DAP Assessment Report

File Reference DA 2019/723

Property Lot: 61 DP: 1240776, 10 Tidepool Street LENNOX HEAD

Proposal Construction of two dwellings and associated earthworks and

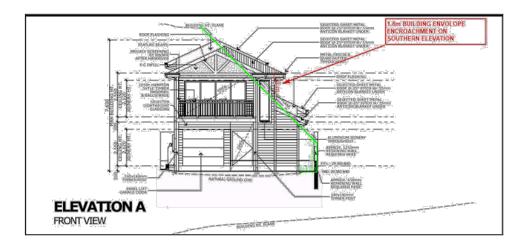
The proposed development breeches the building envelope on the southern boundary by approximately 1.8m. Shadowing diagrams provided by the applicant indicate substantial shadowing on adjoining property to the south. Refer to images below.

Should the proposed development be approved in its current form, a shadow shall be cast on the dwelling on the adjoining allotment to the south. The shadow cast shall be cast on both living area and bedroom windows for extended periods of time.

The proposed development also casts shadows on habitable areas, other than bedrooms, on the southern dwelling on the development lot (Dwelling A). This is envisaged to be severe with the ground floor children's retreat and first floor living areas windows all receiving less than 3 hours of continuous sunlight at the winter solstice.

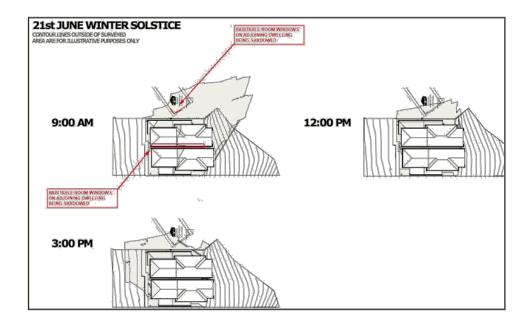
Shadow diagrams provided indicate that the windows of the "child's retreat" of Dwelling A and two of the living area windows of the dwelling on the adjoining property shall receive less than 3 hours of continuous sunlight between 9.00am and 3.00pm at the winter solstice.

The proposed development shall cast a significant shadow on ground floor habitable room windows of the dwelling on the adjoining property to the south.

During the DAP meeting it was noted that the dwelling on the adjoining land has an existing deck area (private open space) that would also be shadowed heavily during the winter solstice.

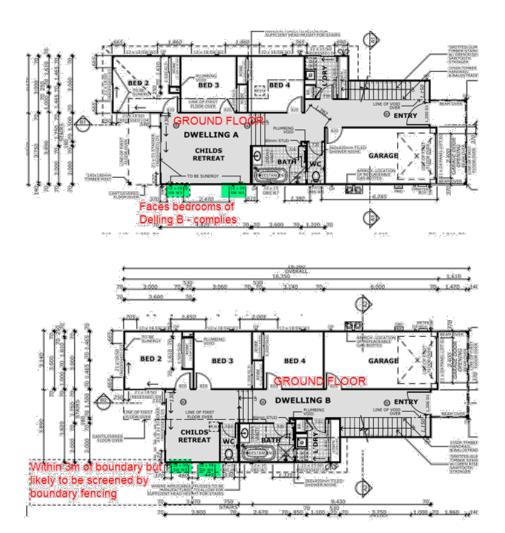
The proposed development has several habitable room windows (excluding bedroom windows) that have a do not meet the privacy criteria of the DCP with respect to the allotment boundary and the other dwelling on the same allotment.

Those that do not meet the privacy criteria are highlighted yellow on the plans below.

The first floor living areas of both Dwelling A and Dwelling B will be impacted by the other dwelling on the lot. In addition, the private open space of the properties located to the north and south will both be adversely impacted as well by the first floor windows.

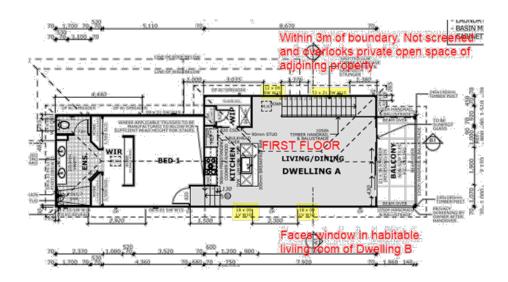
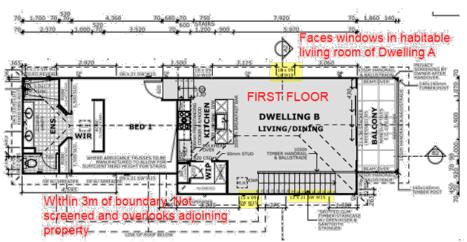
Non-compliant windows in habitable rooms other than bedrooms

Screening measures were requested to be demonstrated in accordance with Council's DCP. Only screening measures on the elevated decks have been included.
